To: John Day River Basin TMDL file **Date:** September 16, 2011
From: Julia Crown, Water Quality Analyst
Section: Watershed Management, Water Quality Division
Subject: Addendum – Clarifications to John Day River Basin TMDL

Figure B-18. Predicted maximum 7DADM temperatures on North Fork John Day River during the model period of 2002. Model results produced every 100 m, except Natural Thermal Potential was modeled 200 m.

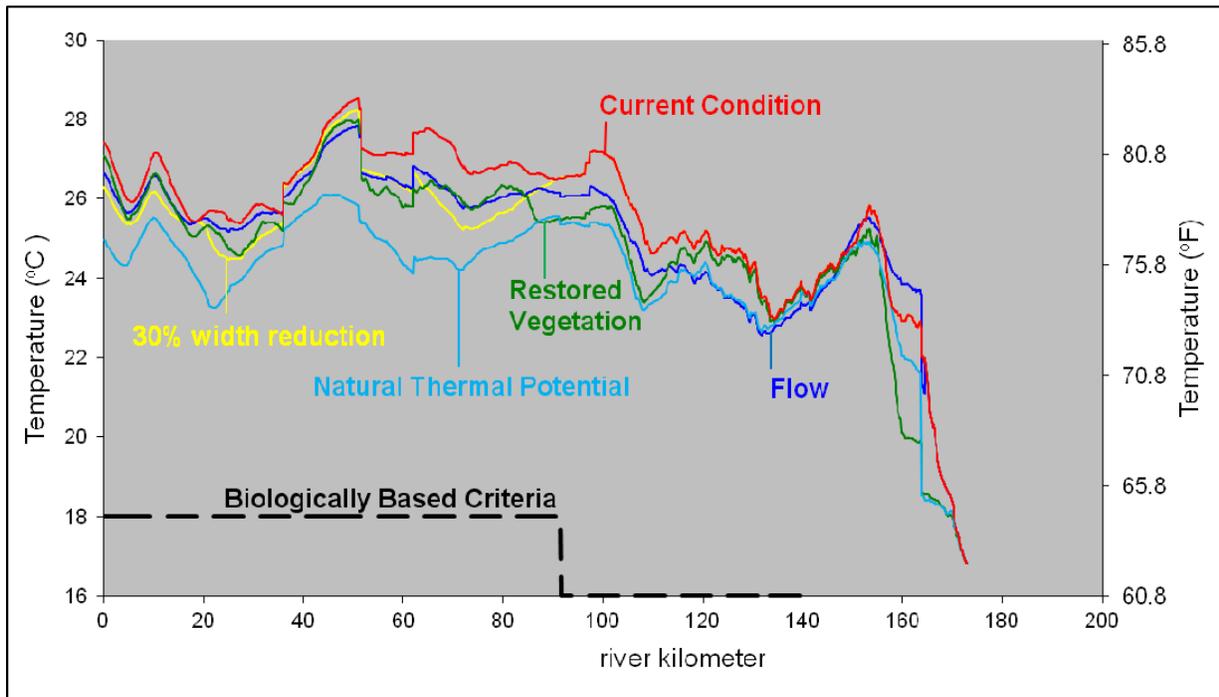
This memorandum amends Appendix B of the John Day River Basin Total Maximum Daily Load (TMDL) document of December 2010. Figure B-18 was incorrectly placed in the document as the same as Figure B-32. Figure B-18 was in error and should be replaced with the figure below. The error was limited to Figure B-18 in Appendix B and did not impact the calculation of TMDL loading capacities (Section 2.4.1(d)) or the determination of nonpoint source loading allocations (Section 2.1.8(h)) as expressed in the final TMDL document. The corrected figure is presented below.
